Title: Advisory Committee on Reactor Safeguards
 Reliability and Risk Assessment
Subcommittee

Date: Friday, March 27, 2009

- Discuss staff resolution of ACRS comments on Appendix A to NUREG-1855
 - Overview of major comments
 - Walk-through of the revised document
- Future work

Figure A-1 Simplified Seismic Initiator Event Tree

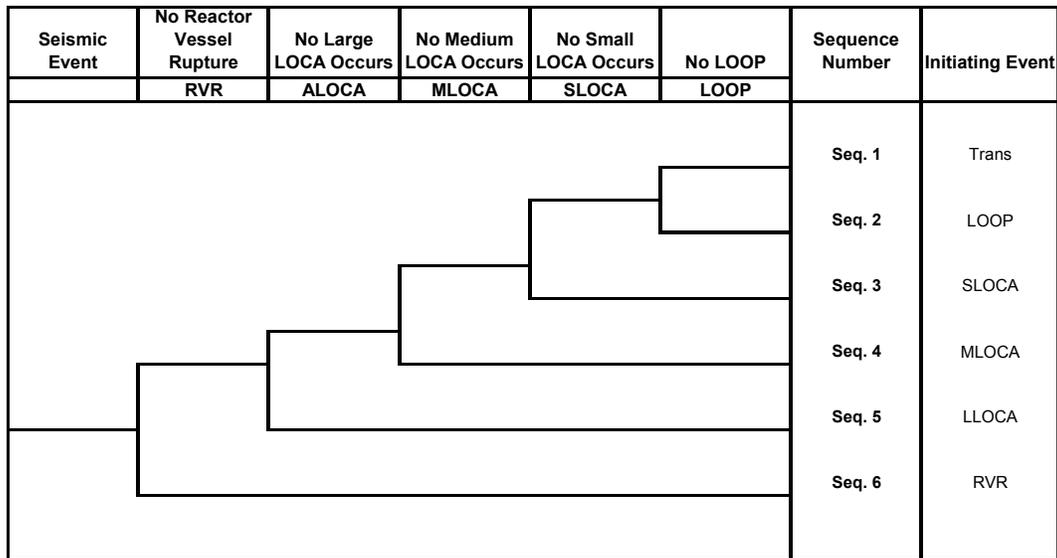
5 CHAIR APOSTOLAKIS: Just a minor comment.
6 On the second yellow. From Table A-9 it can be seen
7 that the frequency of seismic can induce small,
8 medium, or large LOCA. Not "and". "Or". And that
9 was any one of them.

- ACRS Comment: Important seismic dependencies are not described in ways that make it clear that the user will need to identify and model them properly.
- Staff Resolution: Expanded the discussion of the seismic analysis to address the dependencies between seismically induced failures.

17 MR. VANOVER: Right. So then when we get
18 in to the details of the discussion of the bounding
19 seismic assessment, we added some clarification to the
20 LOOP section on the top of page A-14.

19 MR. VANOVER: Yes. We added them up so
20 that's an or gate.
